**Economic Commission for Europe****Inland Transport Committee****World Forum for Harmonization of Vehicle Regulations****Working Party on Passive Safety****Seventy-fifth session**

**UN Regulation No. 153 (Fuel system integrity and electric power train safety at rear-end collision)****Proposal for the 01 series of amendments to UN Regulation No. UN Regulation No. 153 (Fuel system integrity and electric power train safety at rear-end collision)****Submitted by the expert from France<sup>\*,\*\*</sup>**

Model B

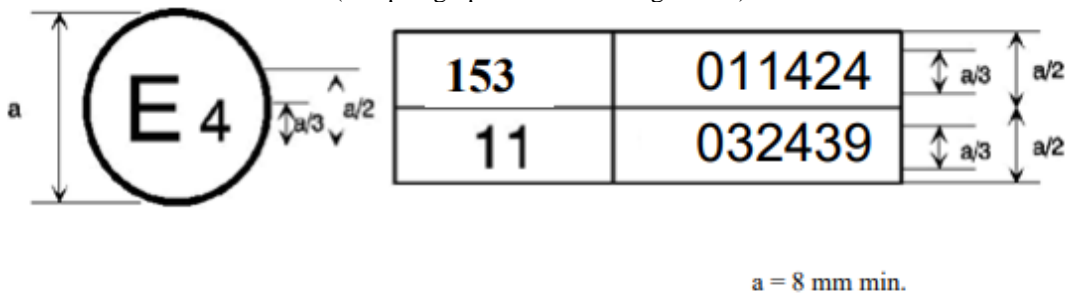
The first two digits of the approval numbers indicate that, at the dates when the respective approvals were granted, UN Regulation No. 153 incorporated the 01 series of amendments and UN Regulation No. 11 incorporated the 03 series of amendments"

Figure 3  
 Jointed Test Finger

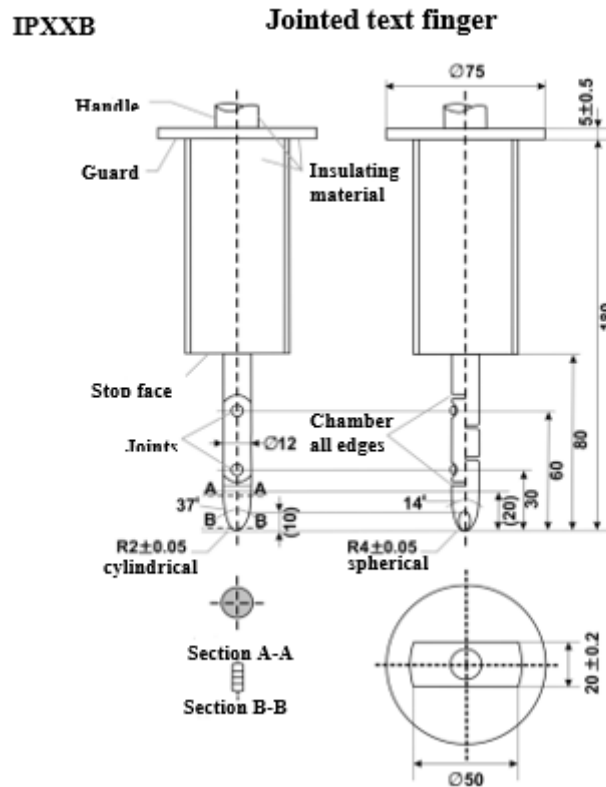
- (a)  $\ominus$  on angles:  $+0/-10$  seconds  $0'0''/0'0'10''$ ;
- (b)  $\ominus$  on linear dimensions:
  - (i) **up to**  $\leq 25$  mm:  $+0/-0.05$  mm;
  - (ii) **over**  $> 25$  mm:  $\pm 0.2$  mm.

Both joints shall permit movement in the same plane and the same direction through an angle of  $90^\circ$  with a  $0$  to  $+10^\circ$  tolerance.
